UNITED STATES OF AMERICA
CIVIL AERONAUTICS BOARD
WASHINGTON, D.C.

Civil Air Regulations Amendment 4b-11

PART 4B^{3/4}AIRPLANE AIRWORTHINESS; TRANSPORT CATEGORIES

Miscellaneous Amendments Resulting from the 1958 Annual Airworthiness Review

FIGURE 4B-2.—MANEUVERING ENVELOPE.

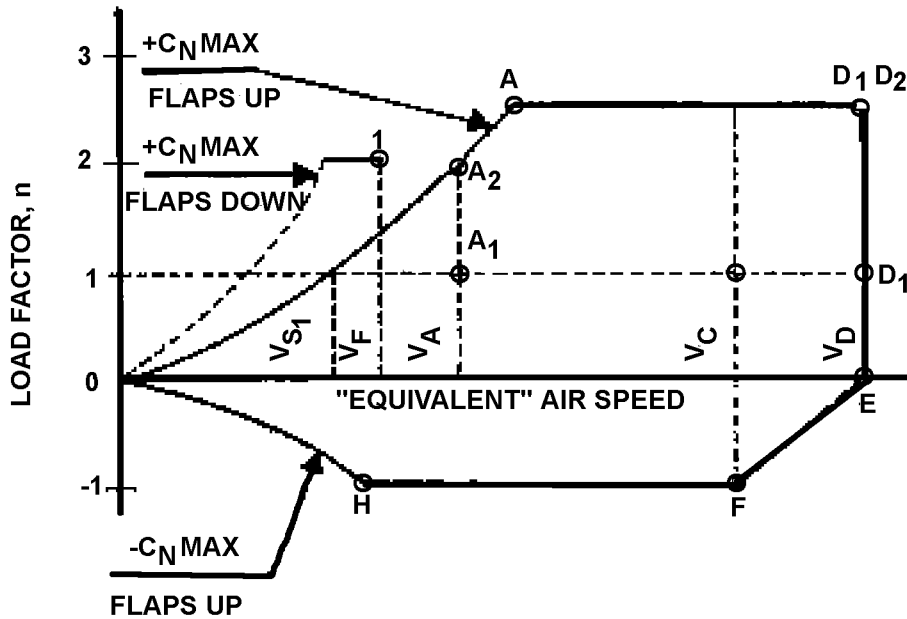
(2) *Design maneuvering speed, V_A .* The design maneuvering speed, V_A shall be equal to $V_{S1} \sqrt{n}$ where n is the limit positive maneuvering load factor at V_C (see § 4b.211(a)) and V_{S1} is the stalling speed with flaps retracted. Both V_A and V_S shall be evaluated at the design weight and altitude under consideration. V_A need not be greater than V_C or the speed at which the positive C_{NMAX} curve intersects the positive maneuver load factor line, whichever is the lesser. (See figure 4b-2.)

(c) *Maneuvering pitching conditions.* The following conditions involving pitching acceleration shall be investigated (see figure 4b-2):

(1) *Maximum elevator displacement at speed V_A .* The airplane shall be assumed to be flying in steady level flight (point A_1 on figure 4b-2) and the pitching control suddenly moved to obtain extreme positive pitching (nose up) except as limited by pilot effort in accordance with § 4b.220 (a).

(2) *Checked maneuverer at speeds between V_A and V_D .* The airplane shall be assumed to be subjected to a checked maneuver from steady level flight (points A_1 to D_1 on figure 4b-2) and from the positive load factor (points A_2 to D_2 , on figure 4b-2) as follows:

47. By amending Figure 4b-2 to read as follows:
